City of Portland, Oregon
Bureau of Development Services
Land Use Services
FROM CONCEPT TO CONSTRUCTION

NOTICE OF A TYPE II_x DECISION ON A PROPOSAL IN YOUR NEIGHBORHOOD

CASE FILE NUMBER: LU 21-054328 LDP

Proposal:
The applicant proposes to divide this 29,832 square foot subject site into three parcels. Parcels 1 and 2 will each be 6,040 square feet in size and Parcel 3 will be 16,236 square feet in size. Parcels 1 and 2 will front along SW Collins Street and be available for future development.

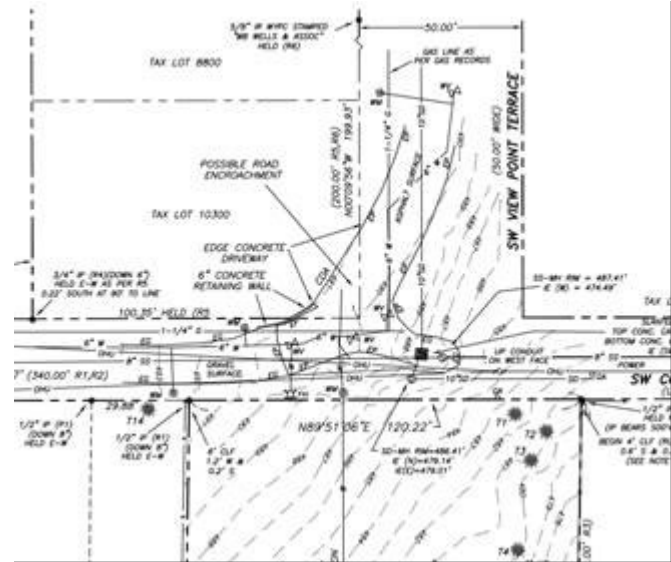
With that said, attention must be paid to the fact that the submitted existing conditions survey shows the

usable roadway surface near the intersection is not fully in public right-of-way. A snip is provided to the right. The roadway surface curves and encroaches substantially onto the private property at the northwest corner of the intersection of SW View Point Terrace and SW Collins St. The applicant has not provided an easement or other document (such as a court judgement) guaranteeing the right of access across the property at the northwest corner of the intersection. The owner of that property has submitted comments to the record stating that she objects to further use of the private property for public access. In the absence of a guaranteed right of access, such as an easement, PBOT must recommend that a drivable surface of adequate width for 2-way vehicle travel be established in the public right-of-way. The improvement may be gravel. The improvement should begin north of the site where SW View Point Terrace begins to curve, then travel south to the site's frontage and west to connect with the portion of SW Collins St. which is in the public right-of-way. A public works permit will be required. PBOT recommends the following conditions of approval to ensure that the street has capacity to provide access to the subject lots without encroaching onto private property:

- Two way vehicular access must be constructed in the public right-of-way adequate to connect the usable portion of SW View Point Terrace to the usable portion of SW Collins Street without encroaching onto private property.
- Construction of the right-of-way improvements must be achieved via a public works permit. The type of public works permit needed will be determined during the public work permit review process. Prior to Final Plat approval, one of the following must occur based on the type of permit
 - a public works permit is issued to construct the requirement improvements OR
 - a public works permit is reviewed to a point where public financial guarantee, such as a bond, be in place to the satisfaction of Public Works Permitting.
